**CITY OF PALO ALTO  
CITY COUNCIL  
Special Meeting  
Monday, April 29, 2024  
Council Chambers & Hybrid  
5:30 PM**

2. Review of Rail Grade Separation Alternatives for the advancement of the alternatives into the preliminary engineering and environmental documentation phase; CEQA status – statutorily exempt under CEQA section 15262 (feasibility and planning study).

## City Council Staff Report

# Meadow/Charleston Viaduct

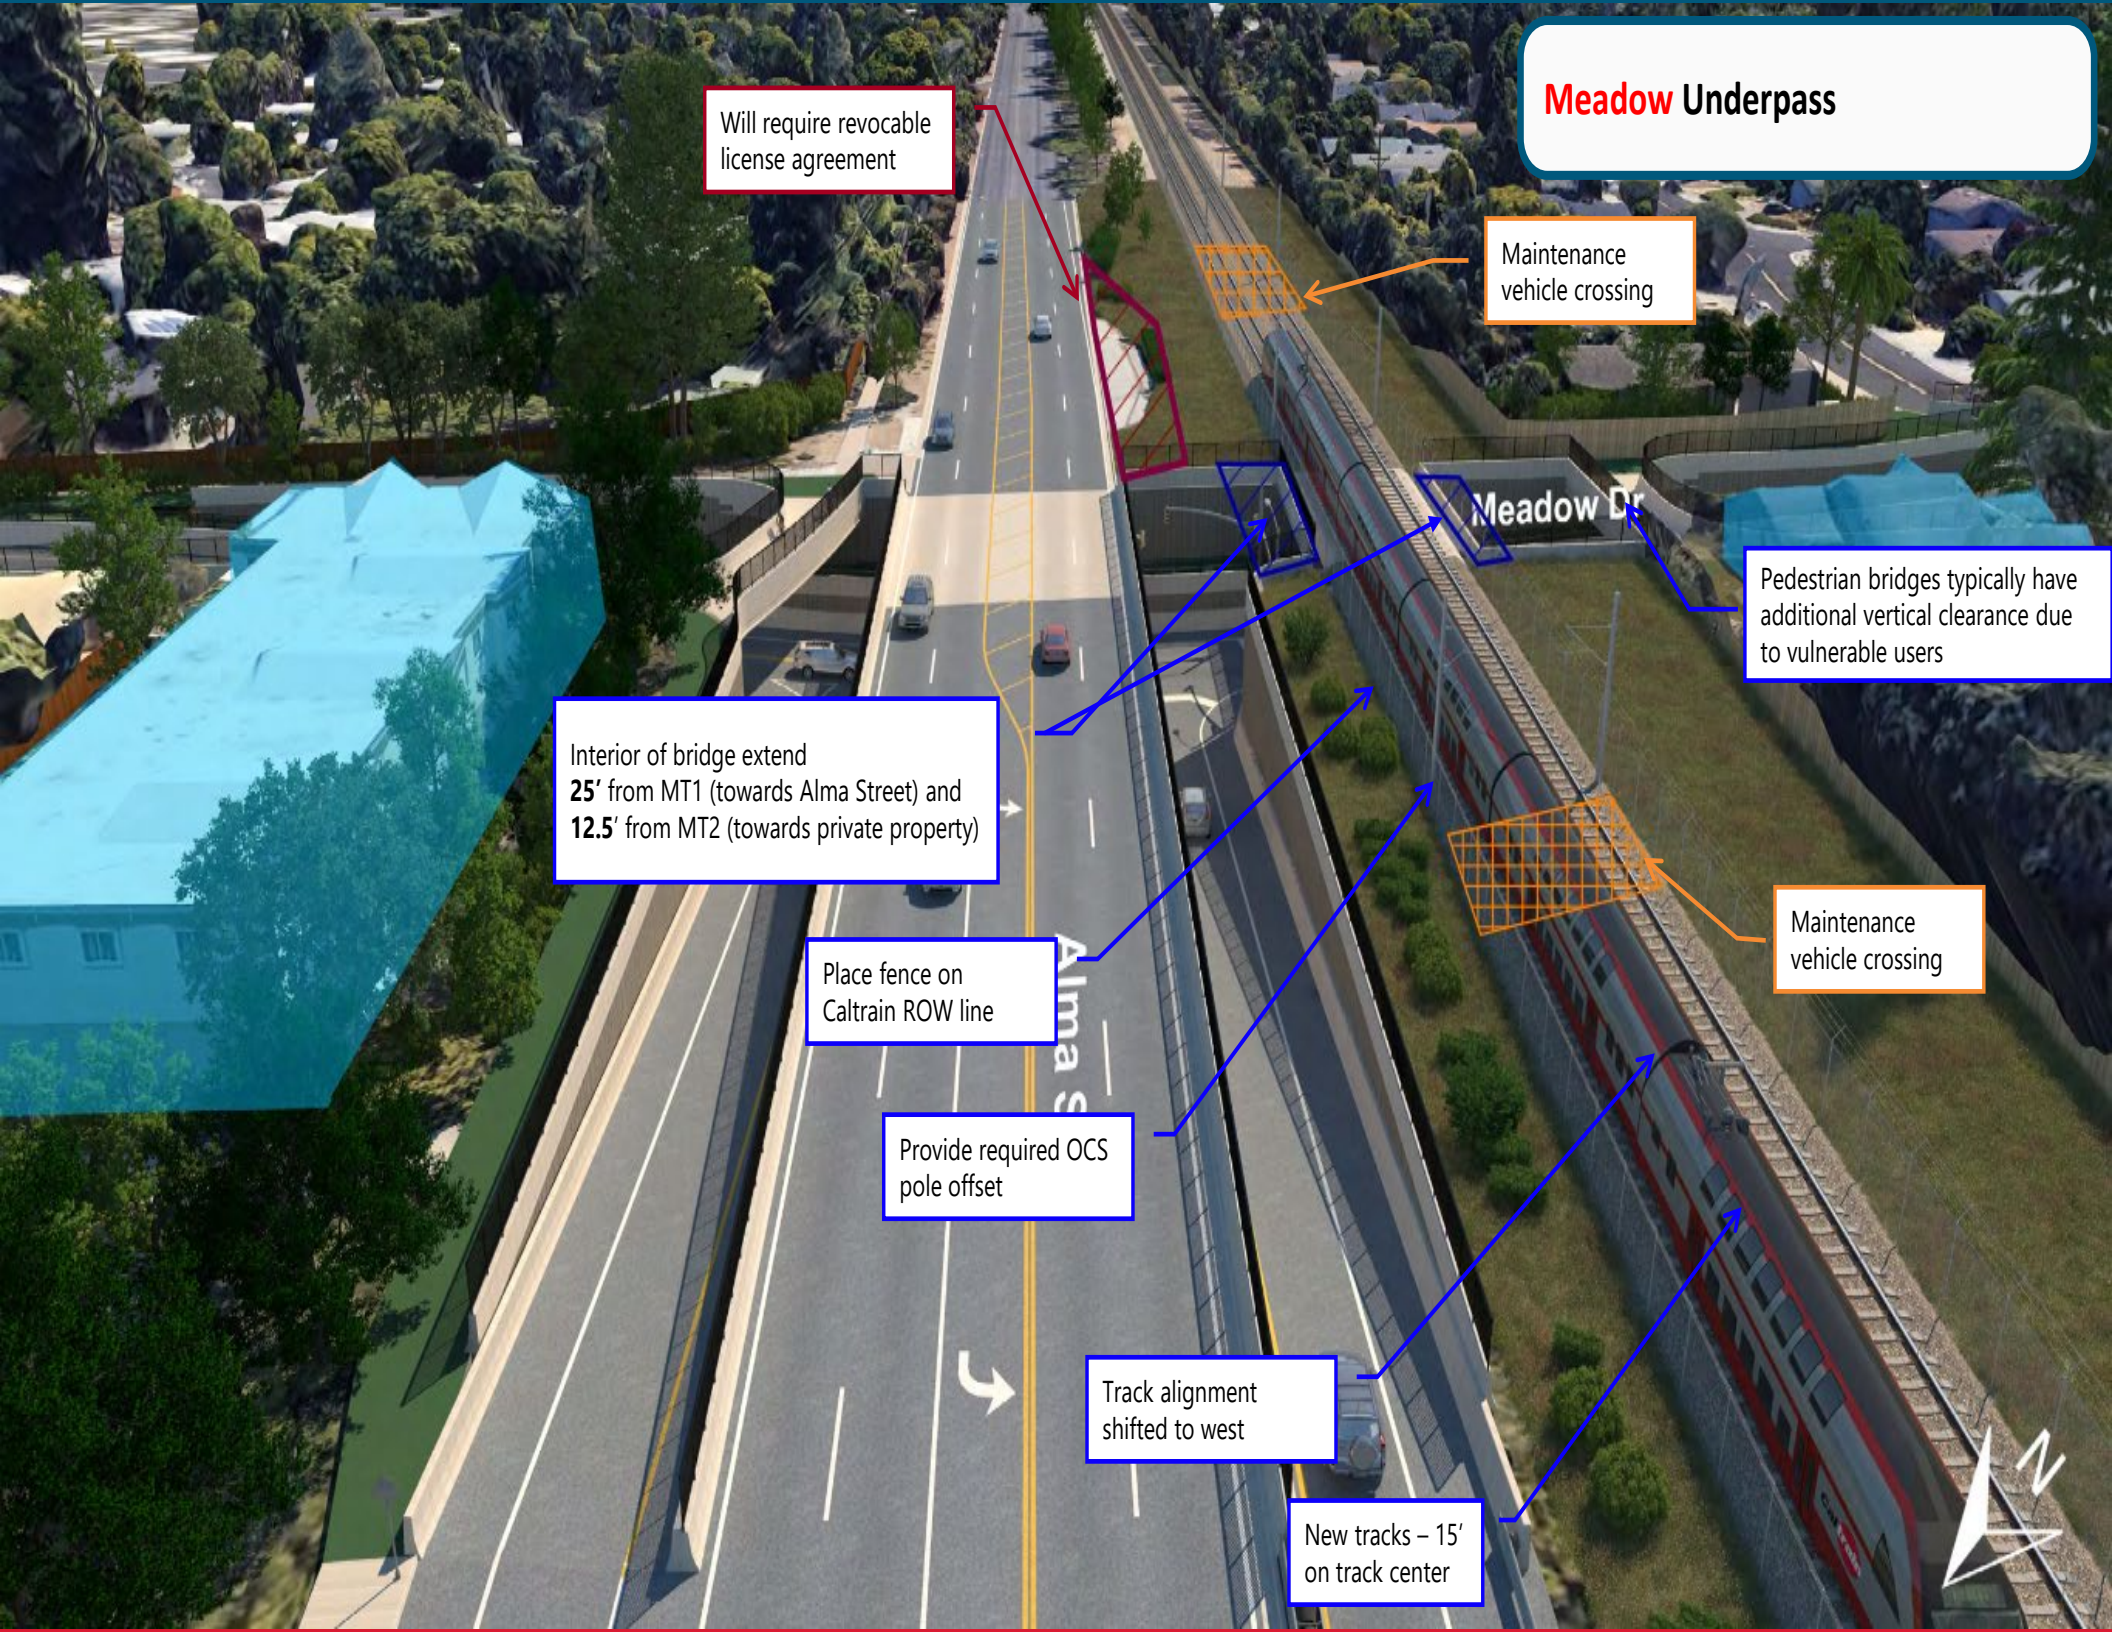
Provide required OCS  
pole offset

Track alignment  
shifted to west

New tracks – 15'  
on track center

- Interior of bridge over Meadow Dr to accommodate **25'** offset from proposed MT1 track center (towards Alma St) and **12.5'** from MT2 (towards private property)
- Add maintenance **crossovers** on either side of bridge over Meadow Dr
- **15'-6"** vertical clearance is allowed but will require a **variance** and sacrificial beam with an **agreement** for the City to cover the cost (of repair and Caltrain operations) if beam were to be struck

Charleston Rd

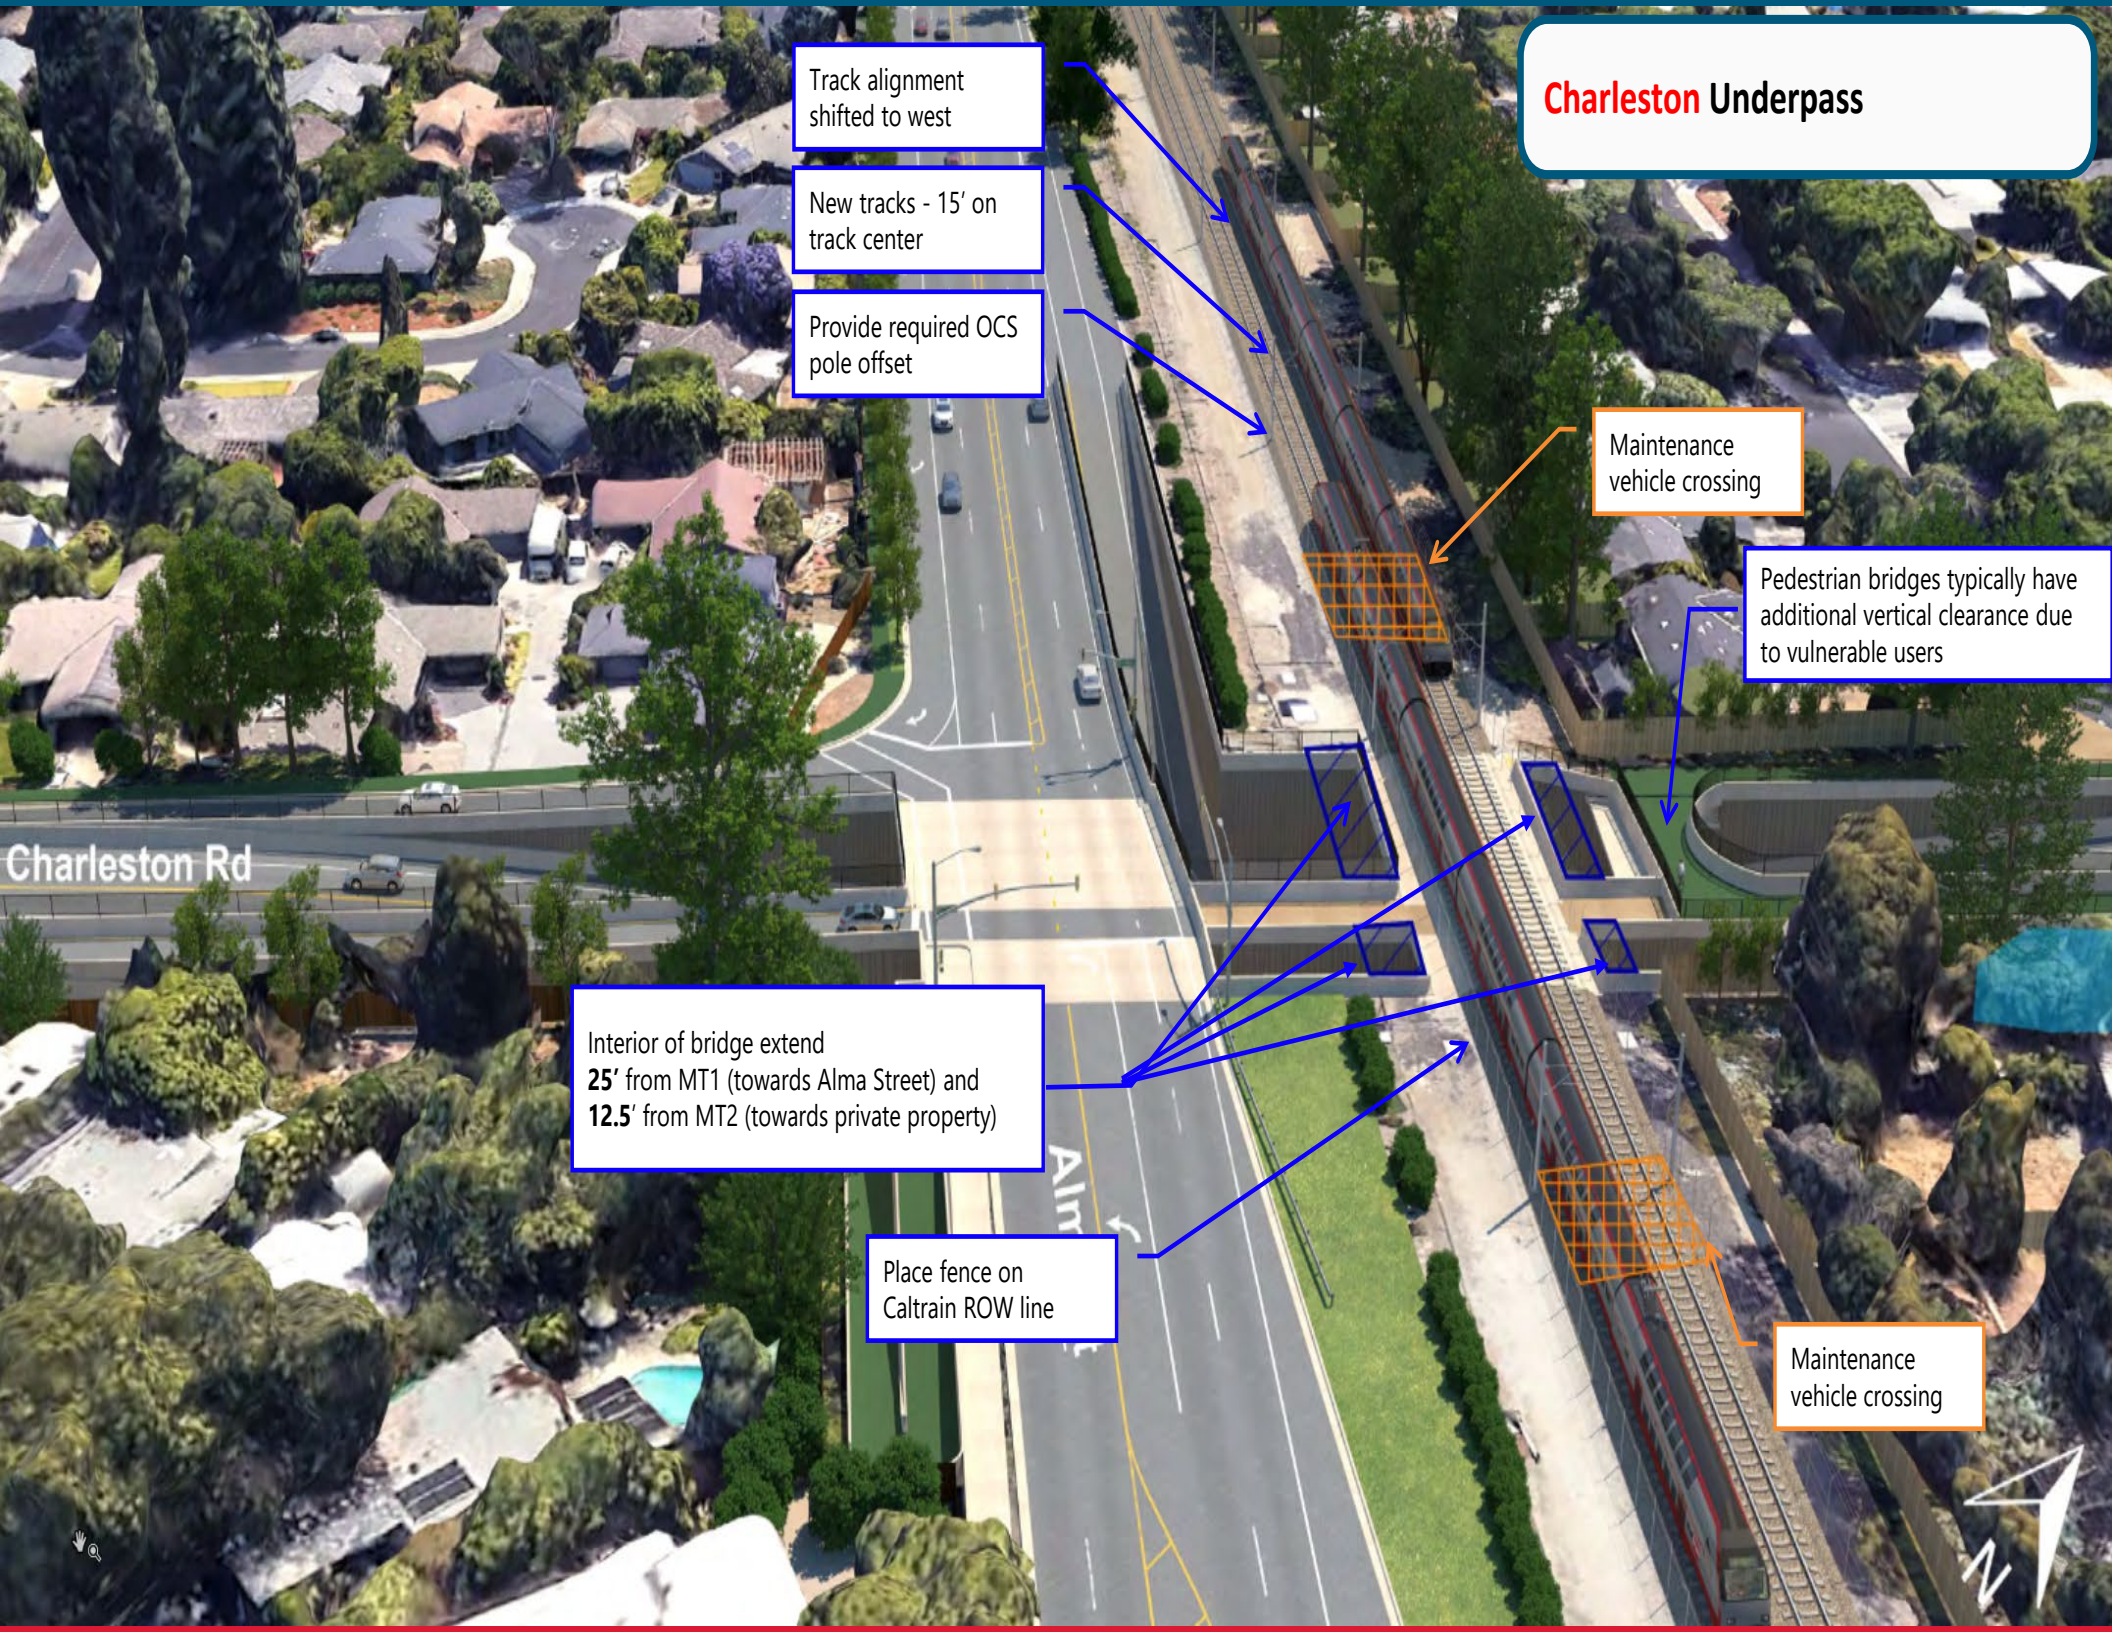
Provide required OCS  
pole offset

Maintenance  
vehicle crossing

Pedestrian bridges typically have  
additional vertical clearance due to  
vulnerable users

- Interior of bridge over Charleston Rd to accommodate **25'** offset from proposed MT1 track center (towards Alma St) and **12.5'** offset from proposed MT 2 track center (towards private property)
- Add maintenance **crossovers** on either side of bridge over Charleston Rd
- **15'-6"** vertical clearance is allowed but will require a **variance** and sacrificial beam with an **agreement** for the City to cover the cost (of repair and Caltrain operations) if beam were to be struck
